MISTER CAR WASH

SITE CONSTRUCTION PLANS

SITE PLAN SUBMITTAL

VICINITY MAP
SCALE: 1"=600'

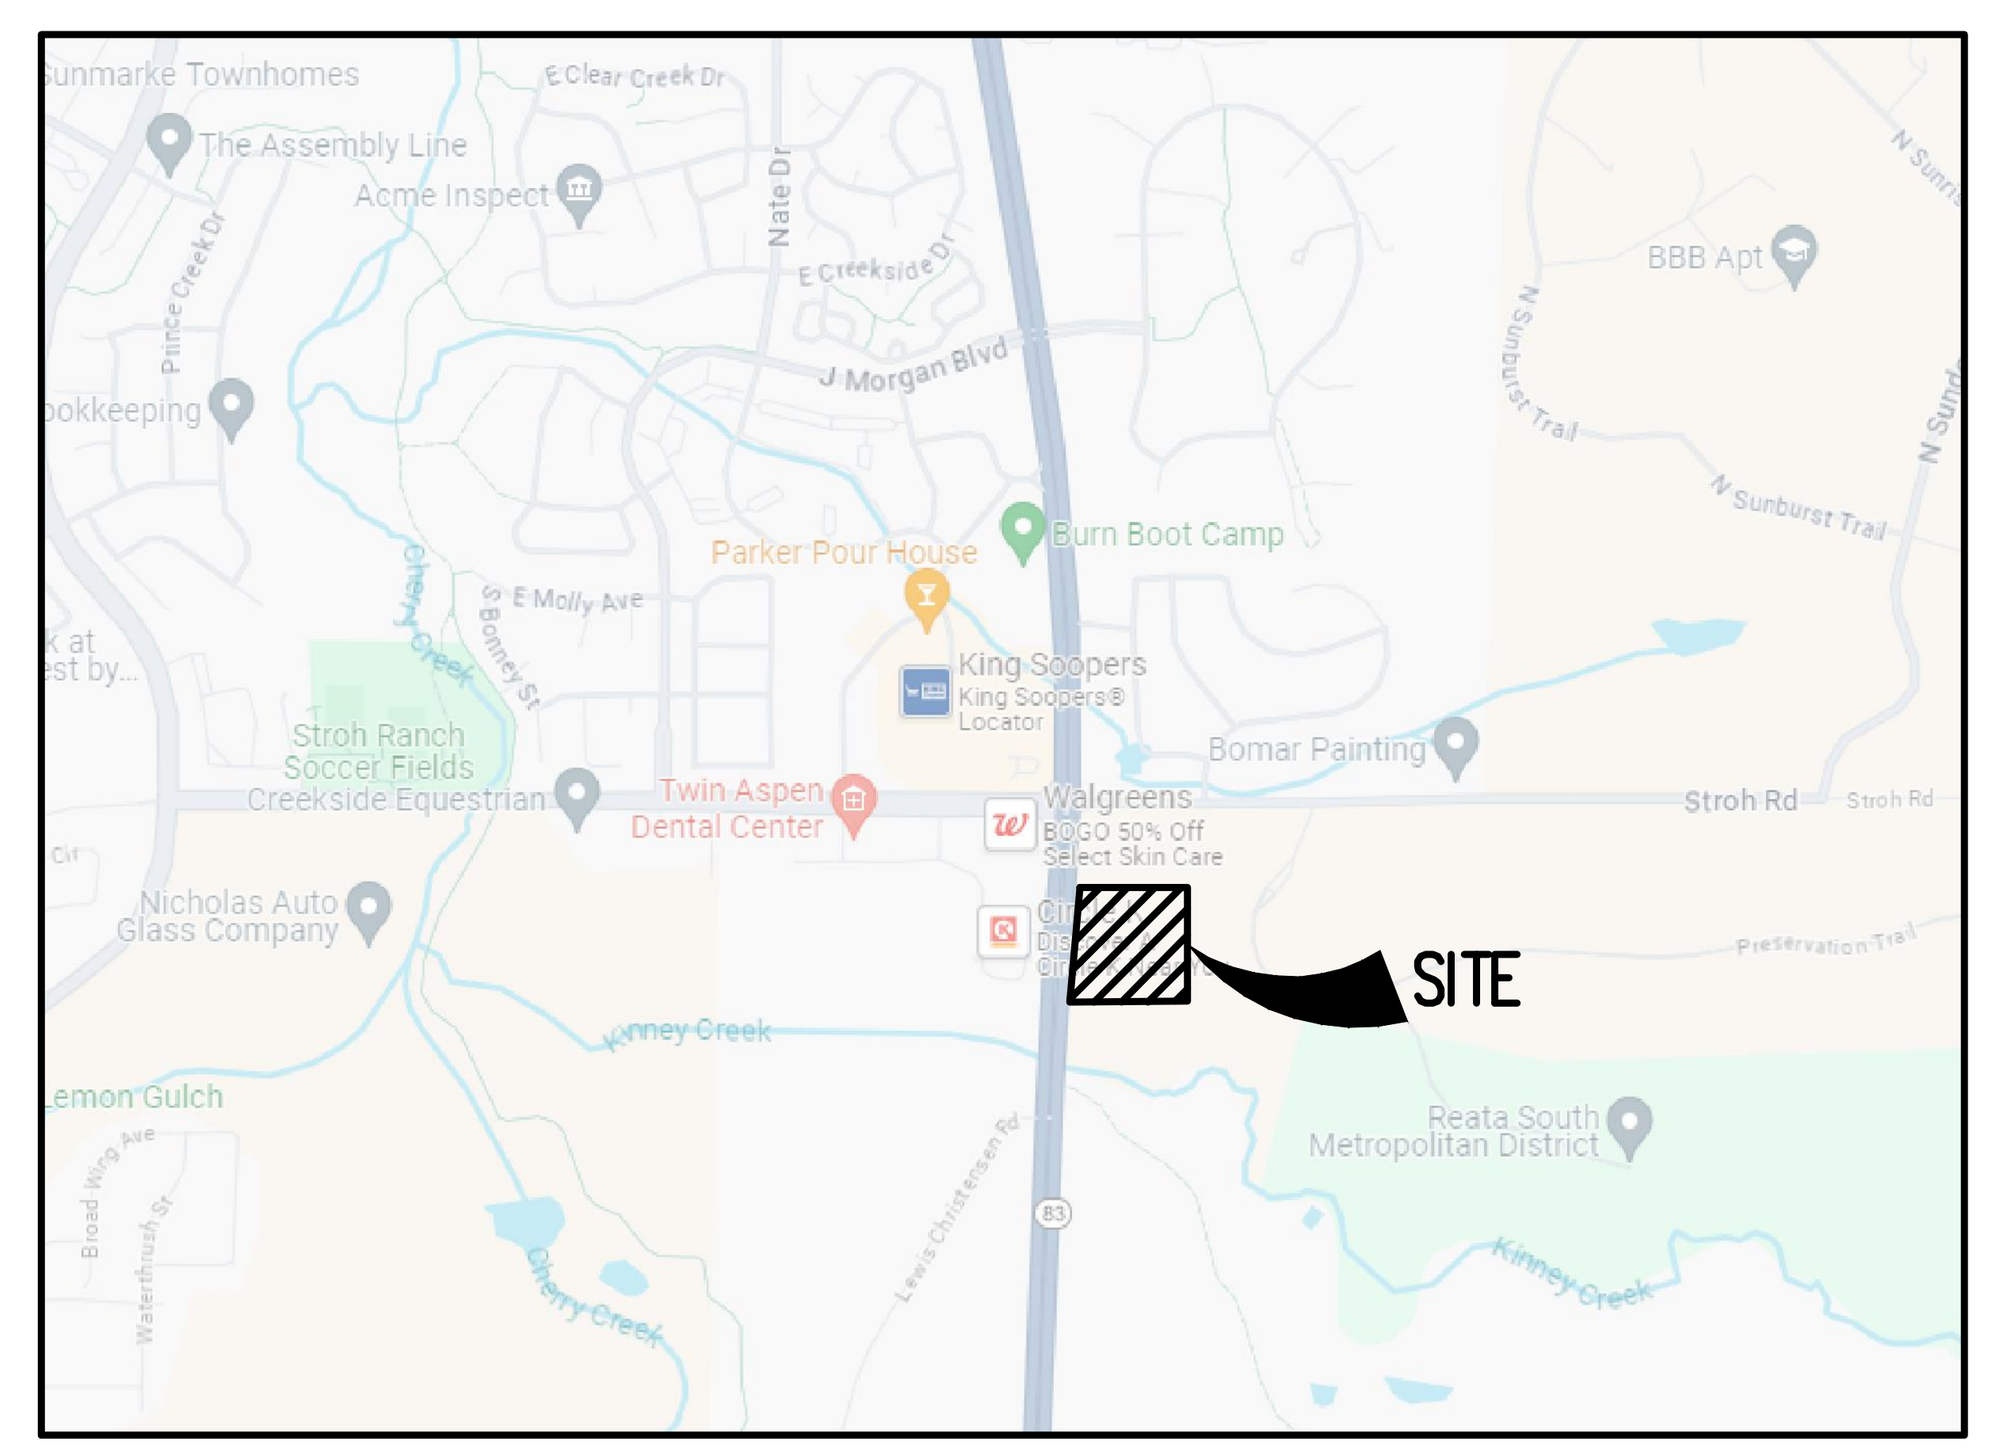
The Vicinity Map shall be at a scale of 1"=2,000' and include location and names of all aerial roadways within one mile of proposed construction. Include any major drainageways in this area.

GRADING PLAN

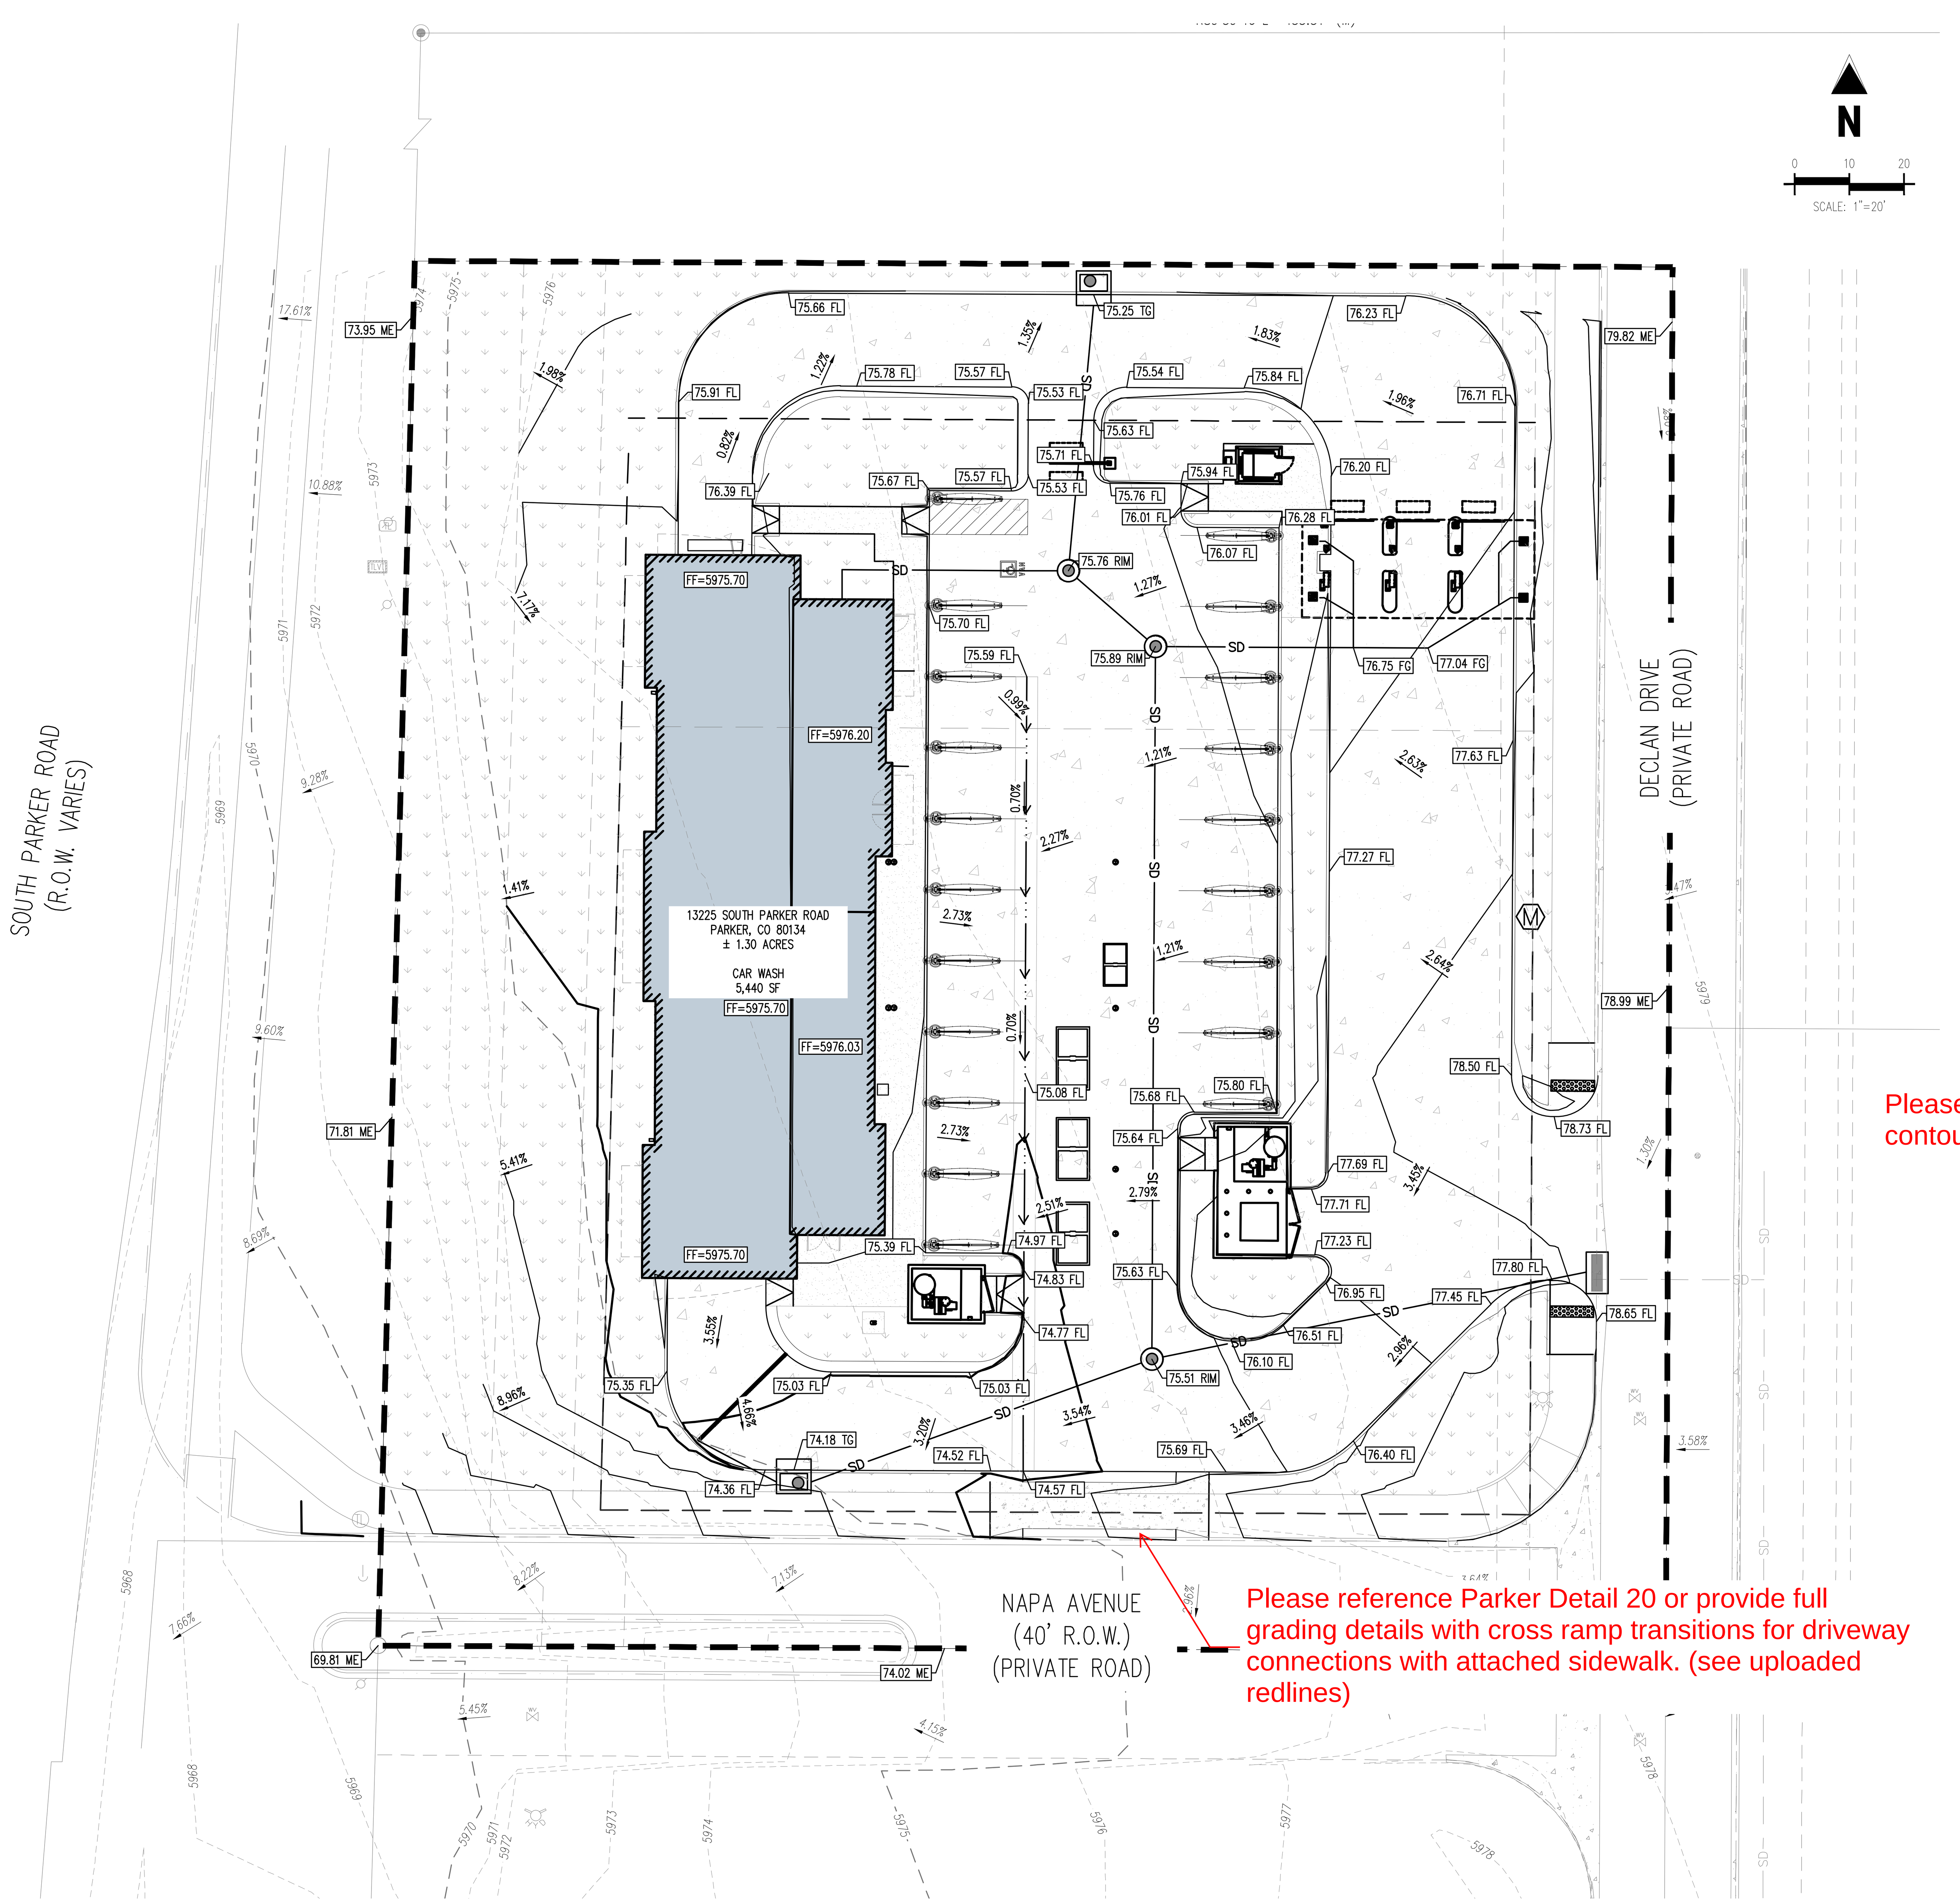
Please include existing and proposed contour labels on all grading plans.

Please reference Parker Detail 20 or provide full grading details with cross ramp transitions for driveway connections with attached sidewalk. (see uploaded redlines)

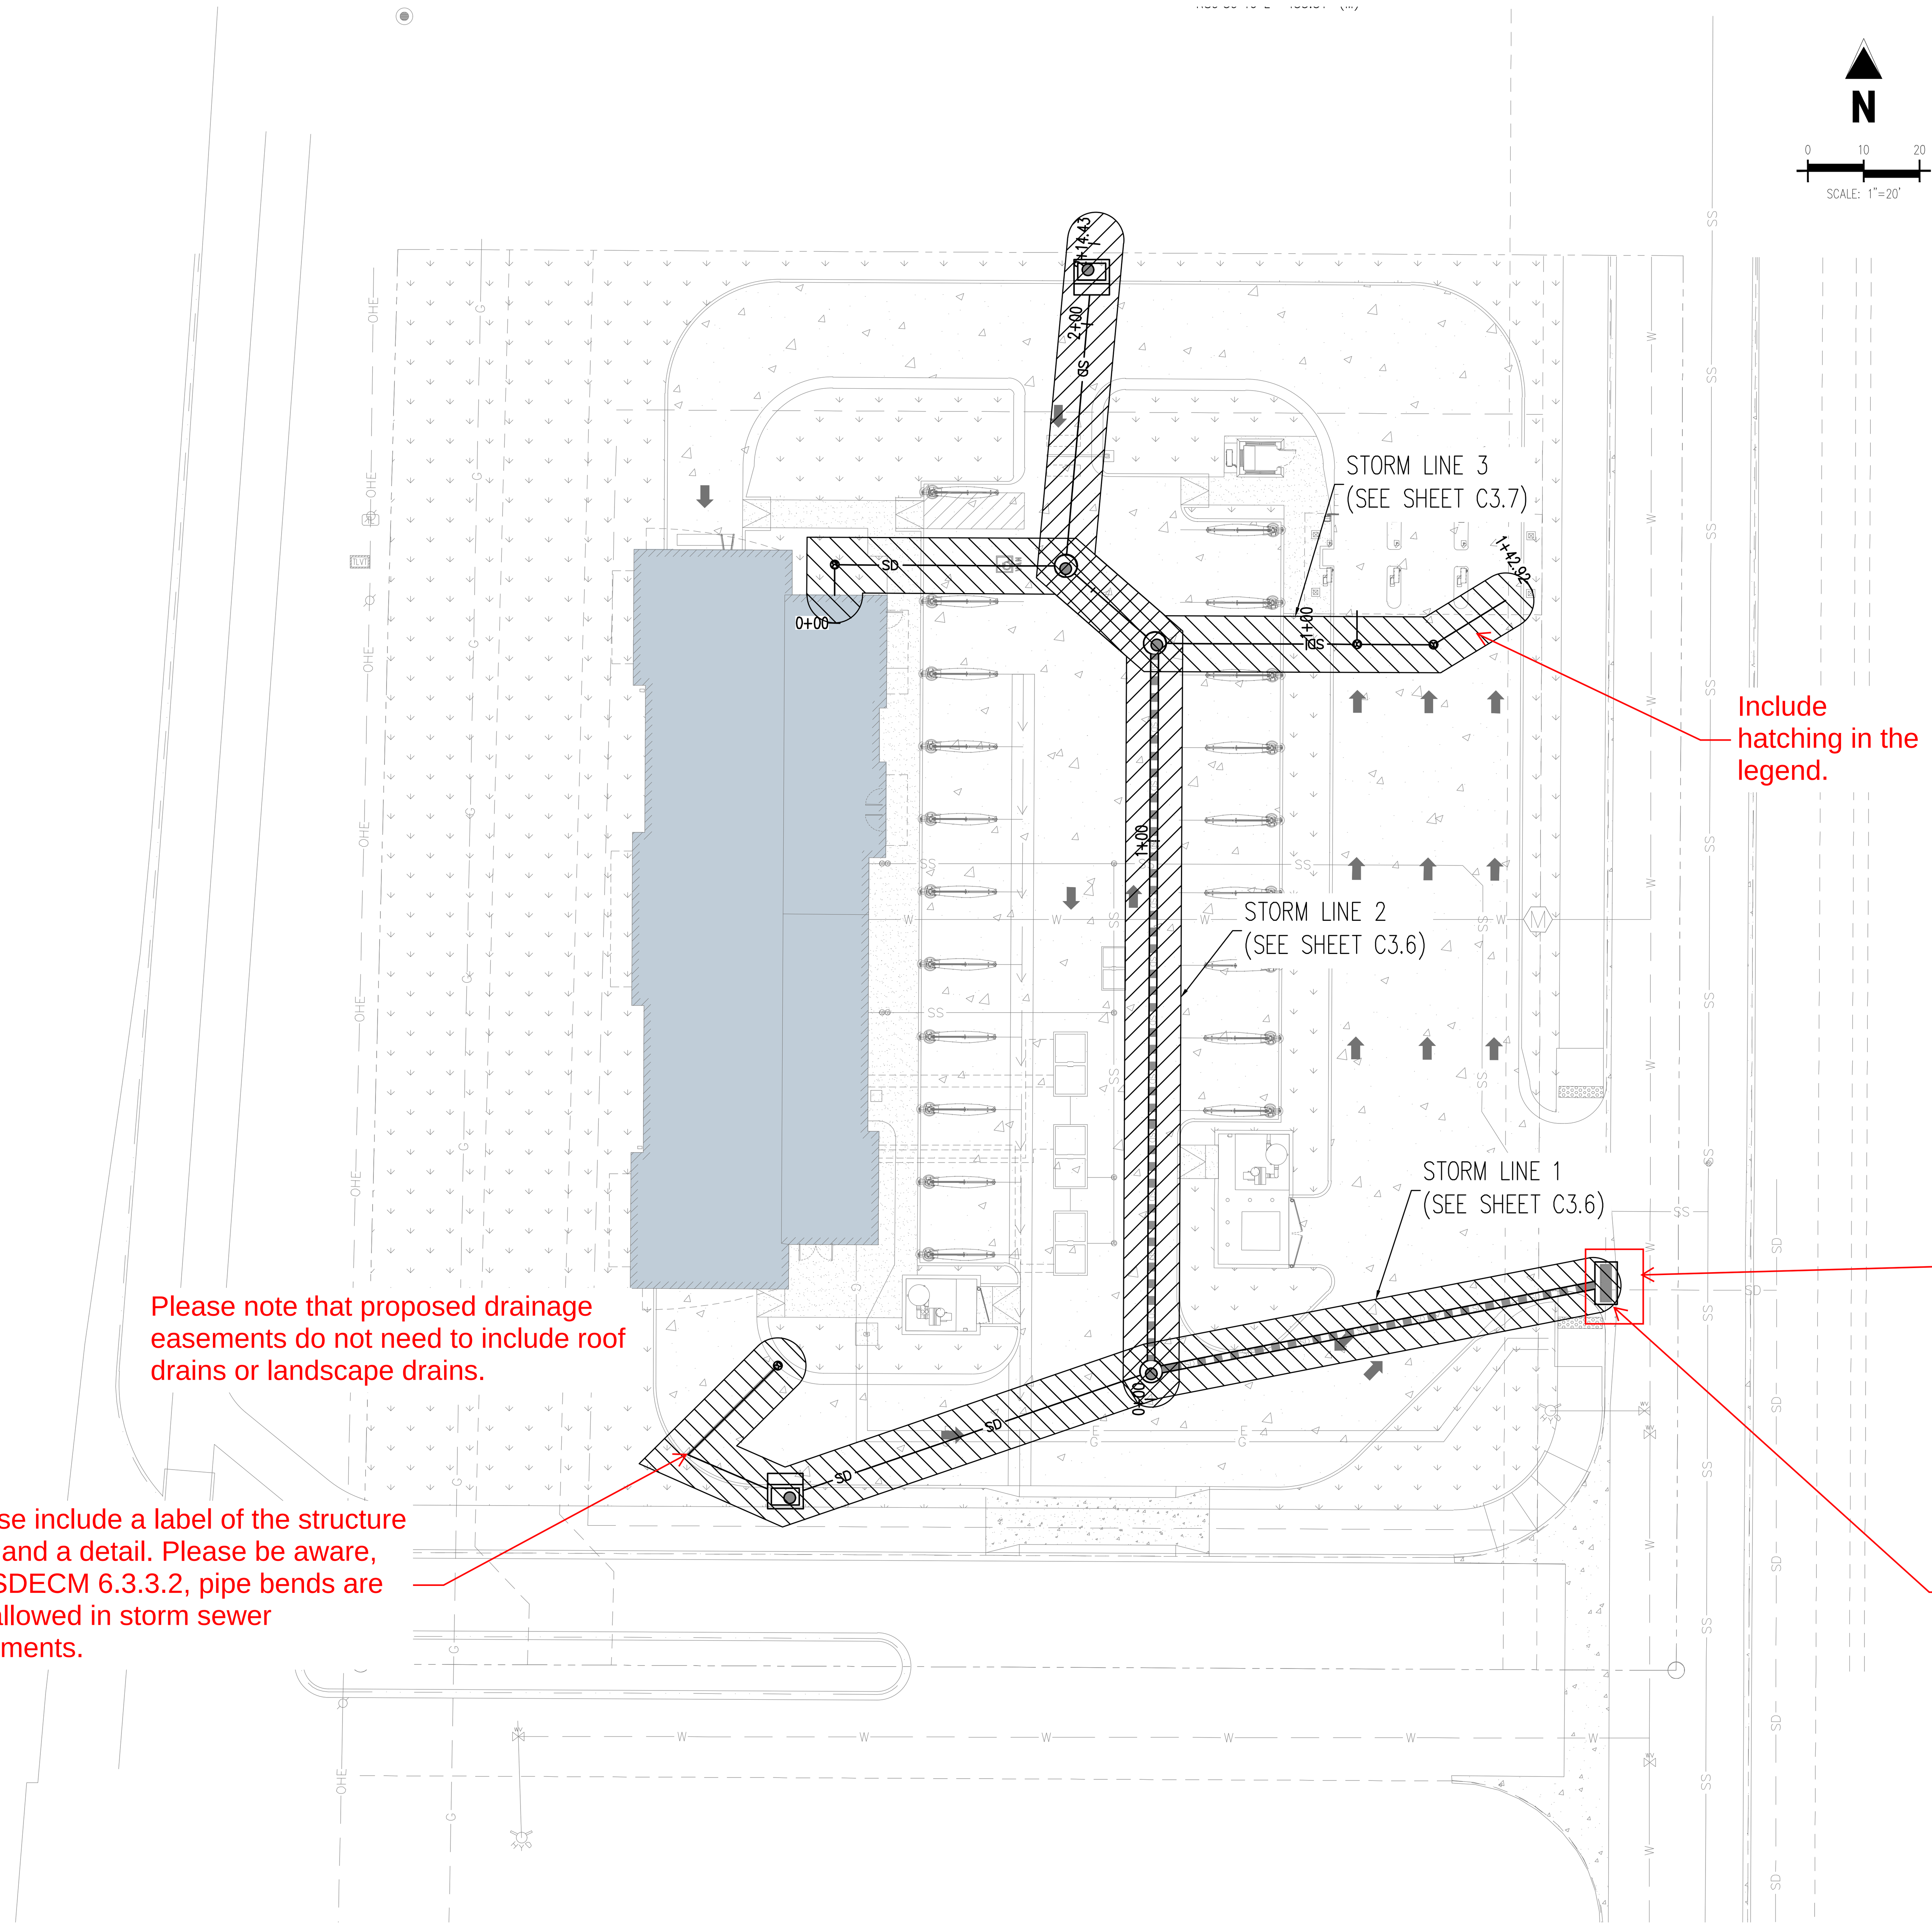
Please dimension and show proposed drainage easements on all Storm Sewer Plans. proposed drainage easements will need to be dedicated by separate document per the Town SDECM. Upon future submittal please provide an exhibit with legal description and name of entity representative/owner to sign.
